Commonwealth Edison
One First National Plaza, Chicago, Illinois
Address Reply to: Post Office Box 767
Chicago, Illinois 60690

December 1, 1978

Subject: Dresden Station Unit 1
Proposed Amendment to Facility
Operating License DPR-2, Appendix A,
Technical Specifications, regarding
Vessel Head Bolting Temperature
NRC SOCKET NO. 50-10

SUBJECT: Stress and Fracture Mechanics Analysis of
Dresden-1 Reactor Pressure Vessel Closure Flanges

BOLT-UP STRESSES (σ) AND
STRESS INTENSIFICATION FACTORS (K_t) FOR
D-1 & D-2

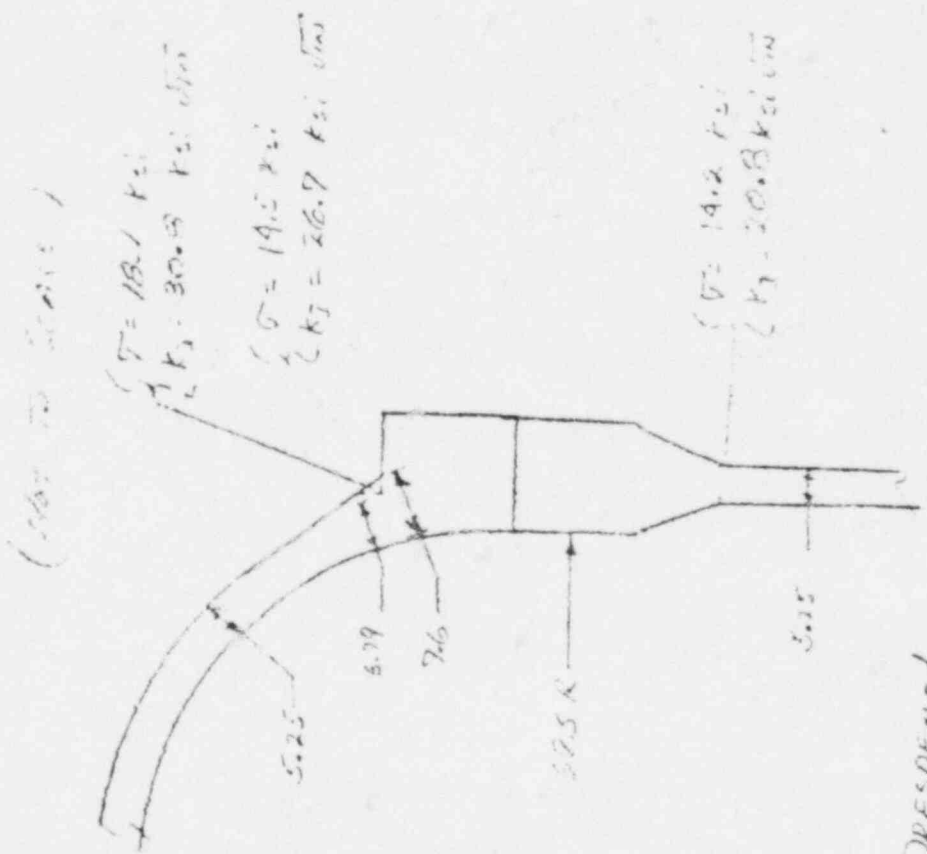
A stress analysis was performed to determine the stresses in the closure flanges, head, and shell at a bolt-up condition of 33,000 psi stud stress. These stresses are shown in the attached figure.

The maximum tensile principal stresses were found to occur on the outside surface and are:

14.5 ksi at the hub to head flange junction
18.1 ksi at the spot face in the head flange hub
14.2 ksi at the hub to vessel shell junction

Mode I stress intensity factors were calculated using the equations in Appendix G of Section III for an assumed 1/4 t flaw and were found to be:

26.7 ksi \sqrt{in} at the hub to head flange junction
30.8 ksi \sqrt{in} at the spot face in the head flange hub
20.8 ksi \sqrt{in} at the hub to vessel shell junction

For comparative purposes, bolt-up stresses were extracted from the B&W stress report for Dresden-2 and are also shown on the attached figure.
